RESPONSE TO REQUEST FOR INFORMATION (RRFI) NO. 121

PROJECT: 2299 Dundas Street West, Toronto, Ontario RJC NO. TOR.122388.0002

Shelter Renovation

Subject:	Consult Mech - RFI 24 - L3 Sink Discontinued
Ref:

RJC: Contractor Proposed L-3 Sink Alternate. Not acceptable - no overflow.

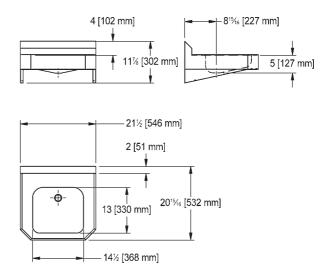
Information Request / Description:	
L-3 sink WT600-8 has been discontinued. Please review attached proposed WT600-7 or advise

Custom hole drilling, specify when ordering, no overflow, accepts 1 1/4" (32mm) waste - not included.

- Proposed sink does not have overflow, thus is not acceptable.
- See attached suggested alternate for review (Franke 214.0493.298)
- Confirm sink can be utilized with original specified carriers.
- Confirm sink can be utilized with original specified faucets.
- Confirm if standard faucet holes can be used, or if custom hole drilling required.
- Submit formal product data for review if alternate is compatible.
